THE RECTORY

DHDC SET
4/24/2023

IANNUZZI

TABLE OF CONTENTS

DOORS

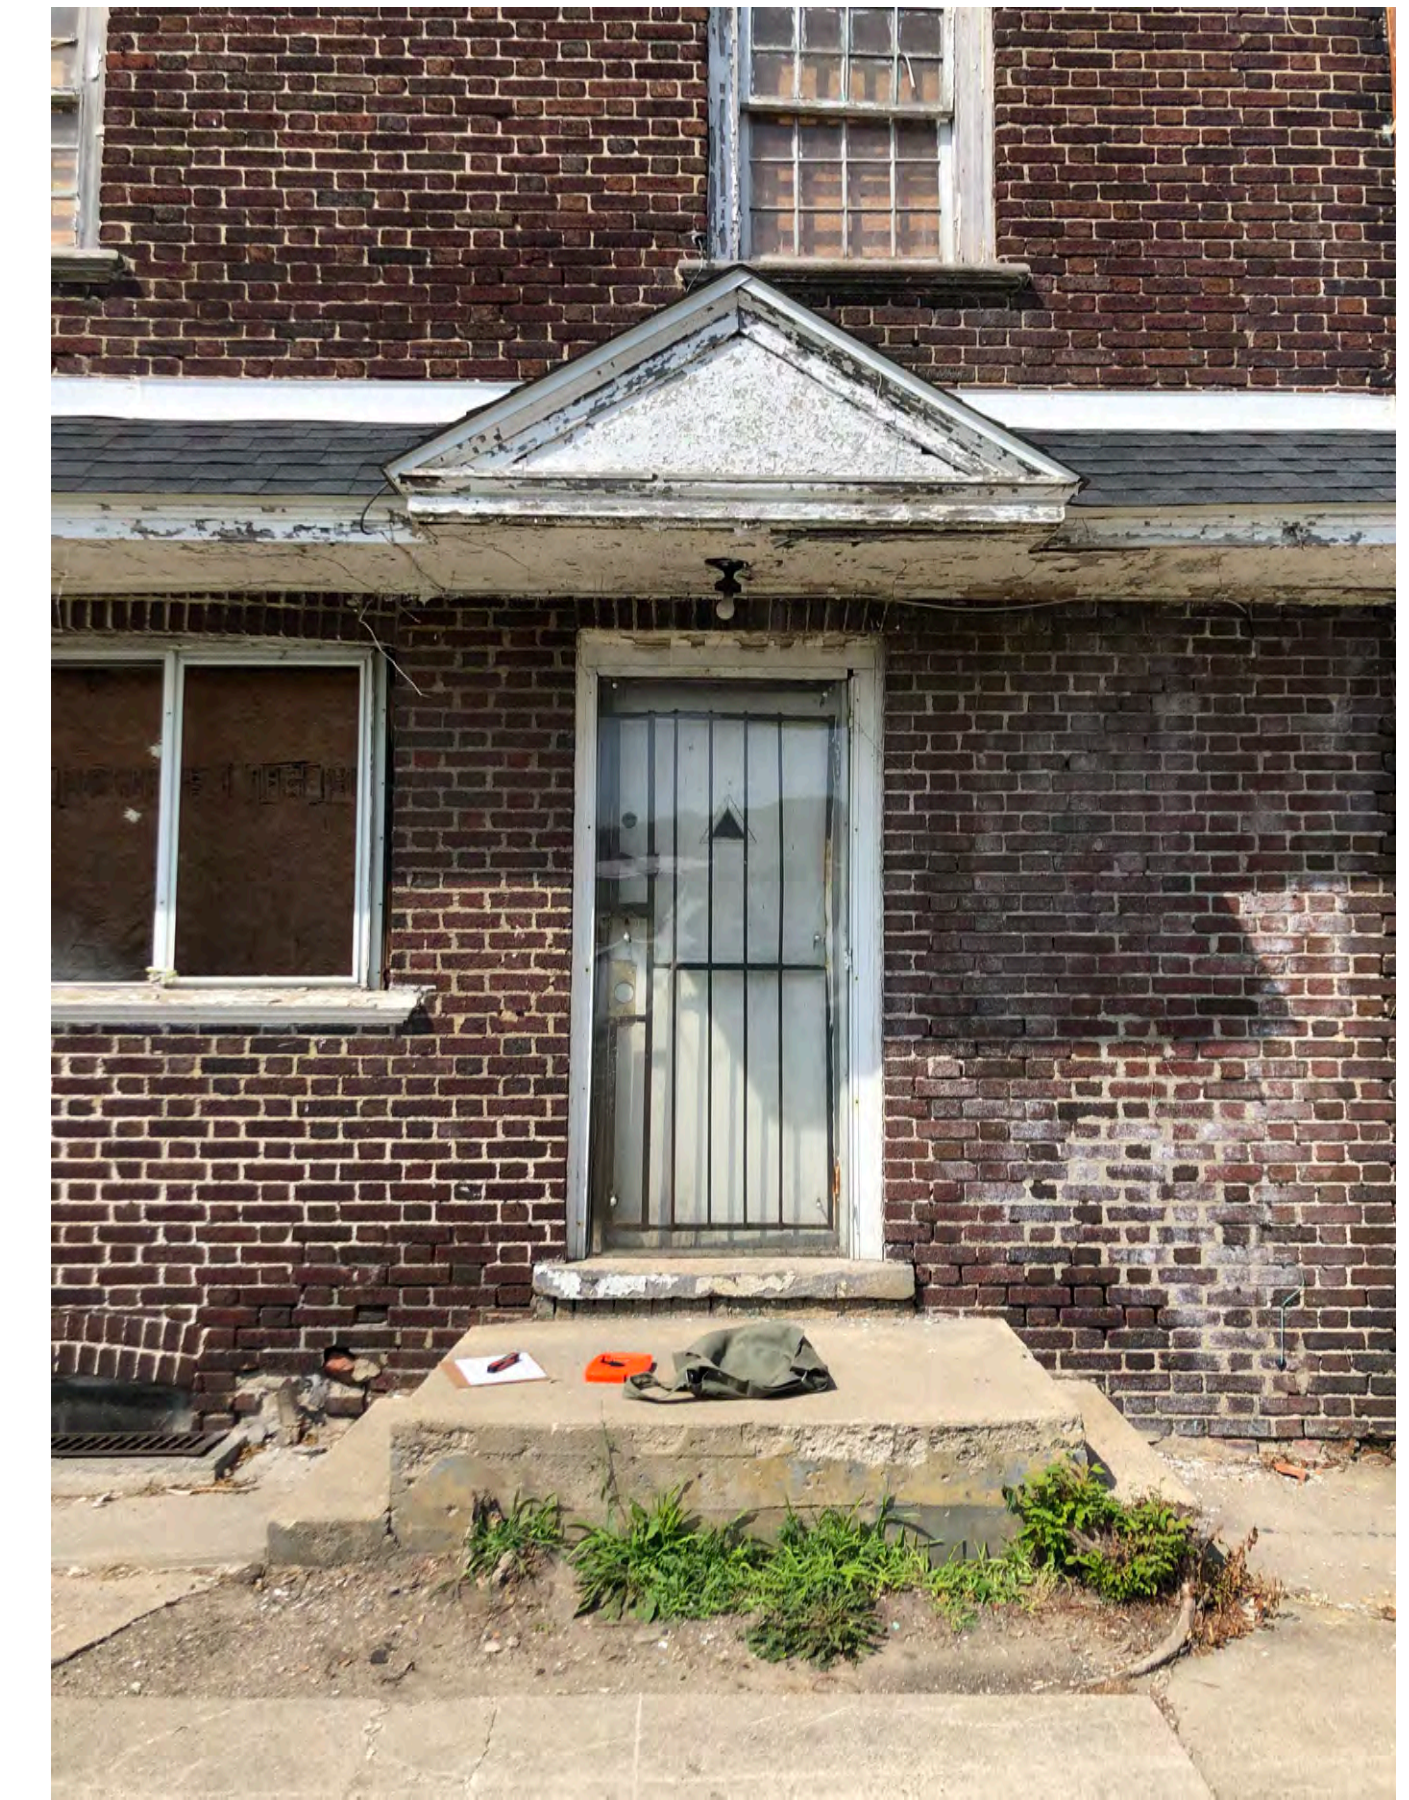
DOOR A - NEW DOOR SILL HEIGHT AND DOOR (103) FOR RESIDENTIAL TENANTS - SEE DOOR SCHEDULE FOR DETAILS

DOOR B - NEW DOOR (102) FOR SECONDARY ENTRANCE TO RESTAURANT - SEE DOOR SCHEDULE FOR DETAILS

DOOR C - NEW DOOR (104) - SEE DOOR SCHEDULE FOR DETAILS

DOOR D - NEW DOOR (105) - SEE DOOR SCHEDULE FOR DETAILS

ALL EXTERIOR NON-HISTORIC DOORS TO BE REPLACED. NORTH ELEVATION DOOR TO BE RELOCATED. SEE PROPOSED ELEVATIONS AND DOOR SCHEDULE.

THE DOOR WOOD TRIMS ARE ROTTED AND NEED TO BE REPLACED AS WELL. BECAUSE THE FIRST FLOOR WILL BE A COMMERCIAL SPACE, ALL EXISTING DOORS ARE NOT TO CODE AND MUST SWING OUT. NEW DOORS WILL MIMIC ADJACENT WINDOW DESIGN.

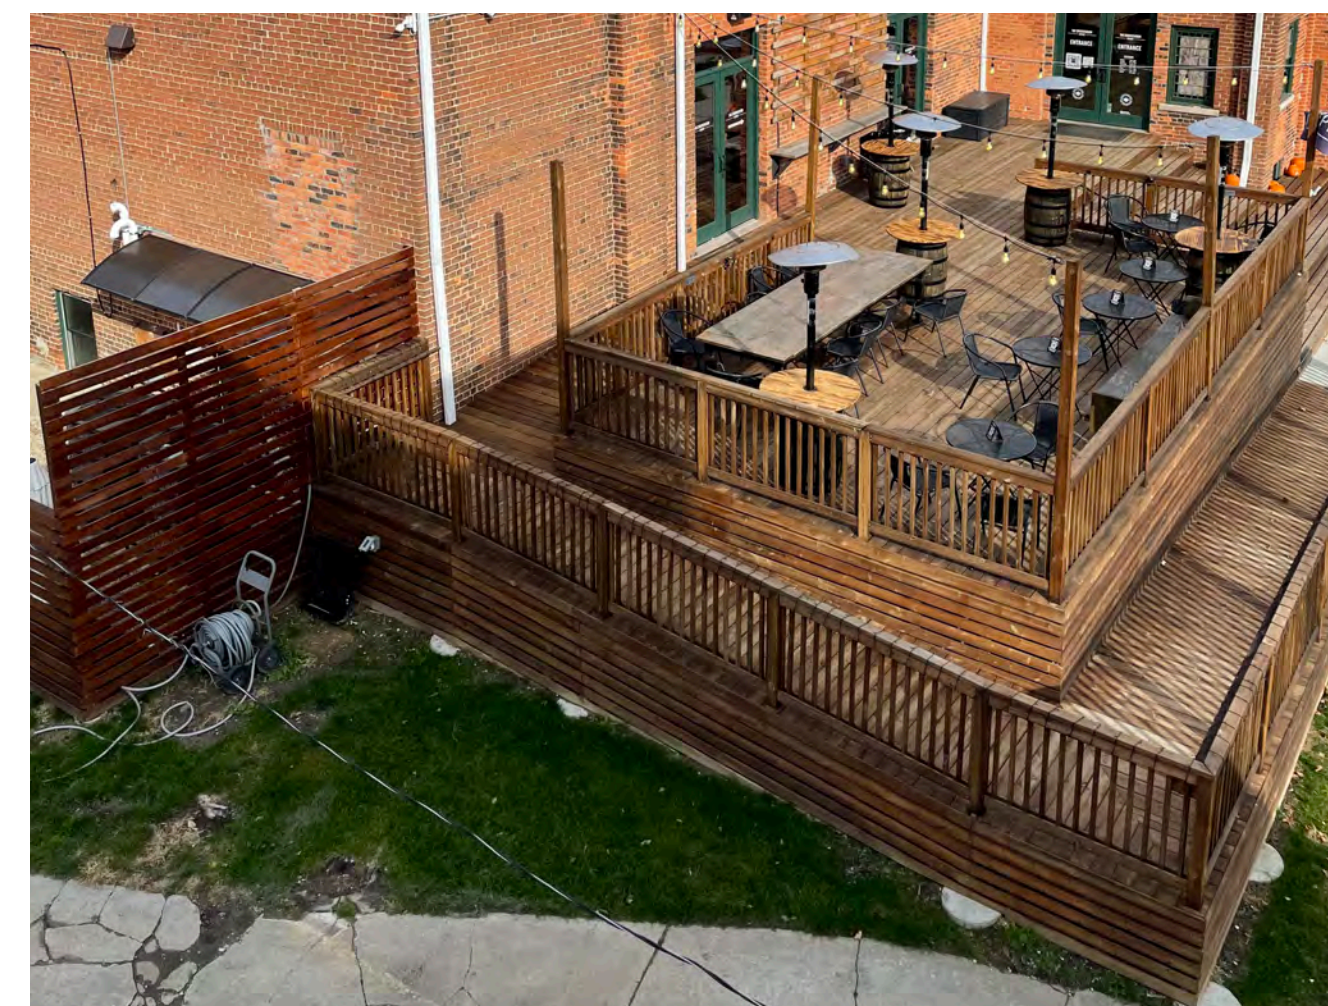
PROPOSED PRIVACY FENCES FOR MEP EQUIPMENT TO MATCH EXISTING MATERIALS OF THE CONGREGATION DECK

PROPOSED ADA RAMP TO MATCH THE EXISTING MATERIALS AND CONSTRUCTION OF THE CONGREGATION RAMP

PROPOSED EXTENDED FENCE WITH GATE TO CONNECT TO EXISTING FENCE WITH GATE AT THE CONGREGATION. MATERIALS AND CONSTRUCTION TO BE THE SAME AS THE CONGREGATION
